Company	Trenz Electronic GmbH
PCN Number	PCN-20190715
Title	TE0745-02-* SPI Flash Change
Subject	BOM change
Issue Date	2019-07-16

#1 Change SPI Flash from N25Q512A11G1240E to MT25QU512ABB8E12-0SIT

Locate Flash (U14) on bottom side of PCB:

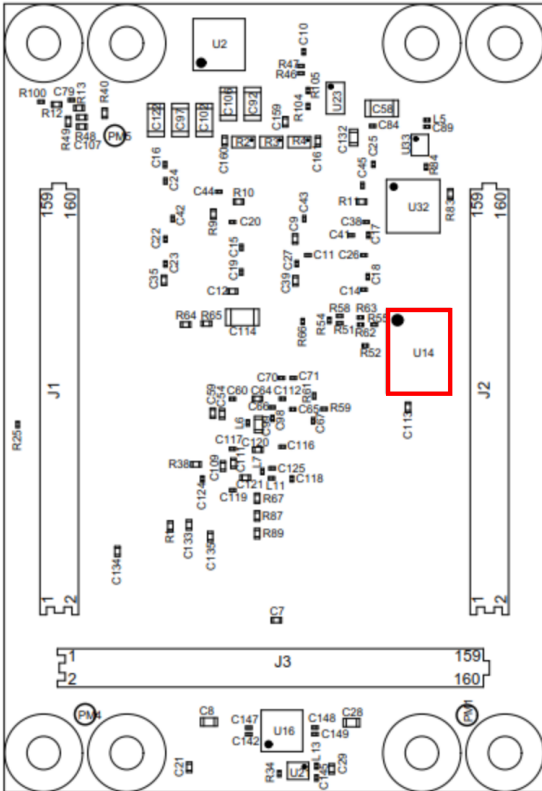
Reason: N25Q512A11G1240E became obsolete.

Impact: None. Both have same JEDEC ID BB20h and manufacturer ID 20h.

old	new
N25Q512A11G1240E	MT25QU512ABB8E12-0SIT
